CERTIFICATE OF APPROPRIATENESS

Property: 1919 Washington Avenue, lots 11 & 12, block 426, Baker WR NSBB Subdivision. The property includes a historic two-story brick storefront commercial building situated on a 14,898 square foot corner lot.

Proposal: Alteration – Install an 8'-6" tall by 20" wide by 18" deep bracket sign featuring neon lettering and detail on the northeast corner of the façade facing Washington Avenue.

3D IMAGES – FRONT FACING WASHINGTON AVENUE

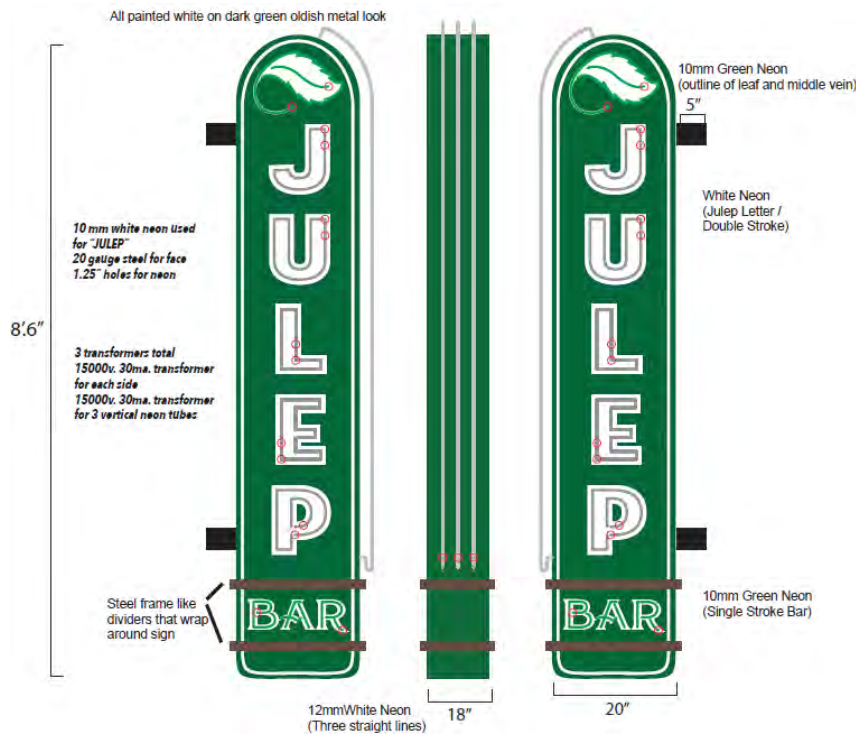
According to the Design Guidelines for the Old Sixth Ward Protected Historic District, as stated on page 20, there is an 'Optional Provision' that Bracket Signs not to be more than 6 square feet (proposed approximately 14 square feet), have letters no taller than 10" (proposed 11"), and that "no neon signs are permitted" (proposed sign features neon lettering as well as other neon design elements).

Although the proposed sign does not meet several Optional Provisions pertaining to Bracket Signs and contains neon, staff believes that the sign is appropriate because it faces commercial Washington Avenue, will not impact neighboring Old Sixth Ward residences, and is historically appropriate to the building and neighborhood. The Old Sixth Ward is also planning on updating their Design Guidelines and is interested in reviewing the current prohibition of neon signage throughout the district.

Additionally, staff believes that the proposed sign meets 4 out of 5 recommended General Provisions for signs within the District, as noted on page 17. The proposed sign is appropriate in size and scale, is constructed of high quality materials and craftsmanship, is located in a logical place on the building (not obstructing key elements or details of the building), and is a style that is compatible with the character of the services (for which it advertises). However, because the proposed sign is neon, it is not indirectly illuminated by an external light source, but is itself illuminated. (See page 10 of this report for excerpt.)

SIGN DETAILS - INSTALLATION

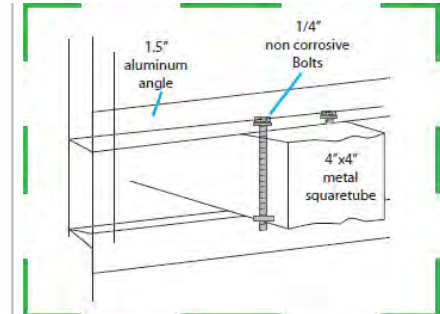
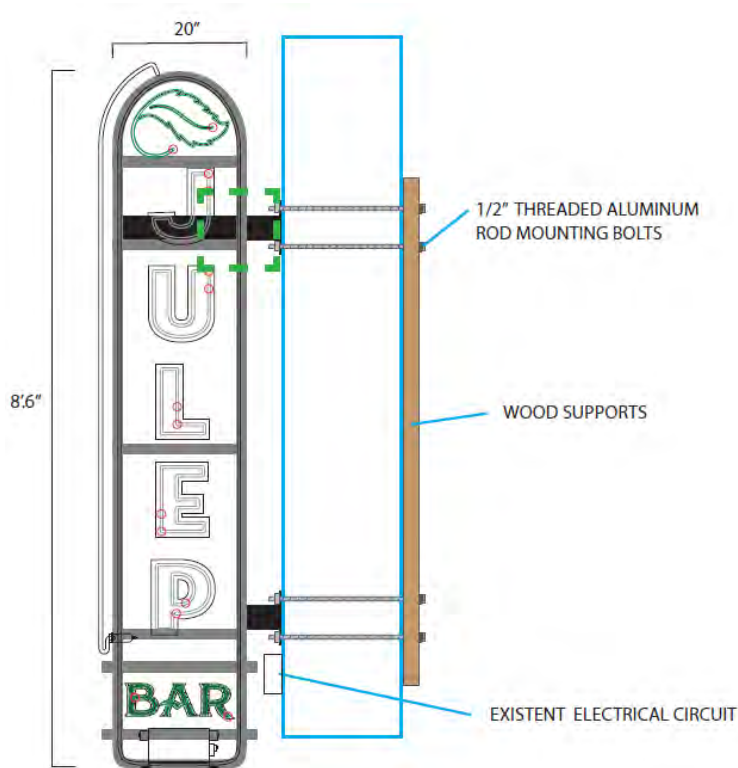
The sign will be installed 15'-6" above grade on the northeast corner of the façade. The brackets will extend 5" from the face of the building. The sign will be fastened to the building with eight ½" aluminum threaded rod mounting bolts (four near the top, four near the bottom). The bolts will be drilled straight through the wall and fastened on the interior. See drawings and photos for more detail.
